ABUTMENT PLAN WITH WING EXTENSIONS

LATEST REVISION DATE 04-12	APPROVED BY BRIDGE ENGINEER <i>Thomas E. M. [Signature]</i>	Iowa Department of Transportation Highway Division	
		STANDARD DESIGN - 30' ROADWAY, THREE SPAN BRIDGES PRETENSIONED PRESTRESSED CONCRETE BEAM BRIDGES DECEMBER, 2006	
		ABUTMENT BACKFILL DETAILS C BEAMS - 0° SKEW	H30-90-06

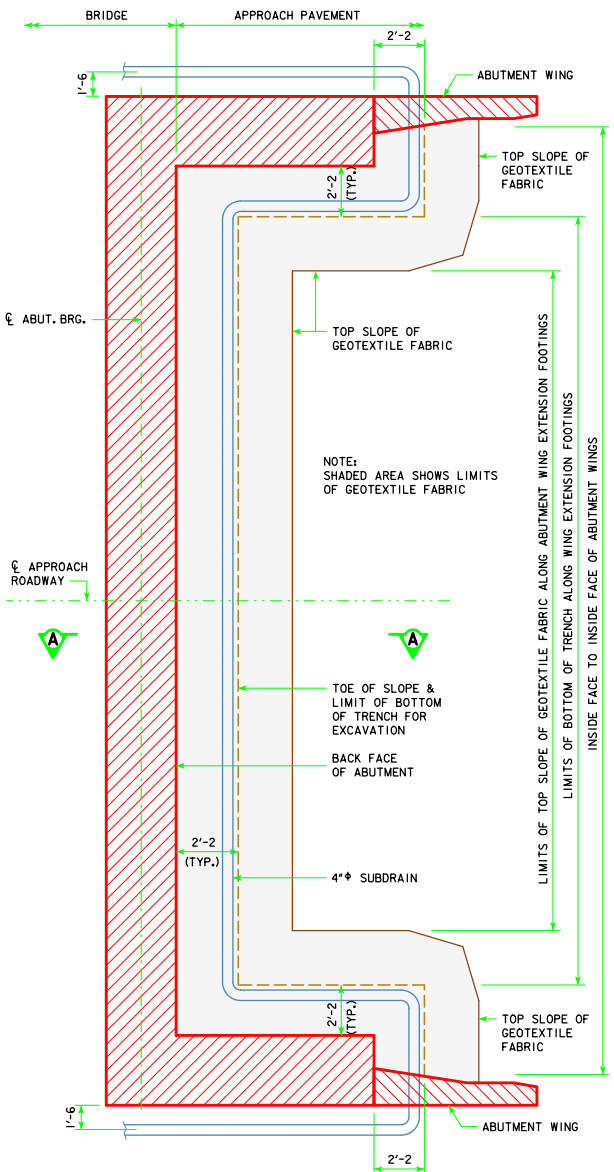
REVISED 04-12 - EXCAVATION LIMIT ON THE FRONT FACE OF THE ABUTMENT WAS CHANGED TO A 3'-0" LIMIT. THE APPROACH FILL WAS IDENTIFIED AS THE GRADING SURFACE.
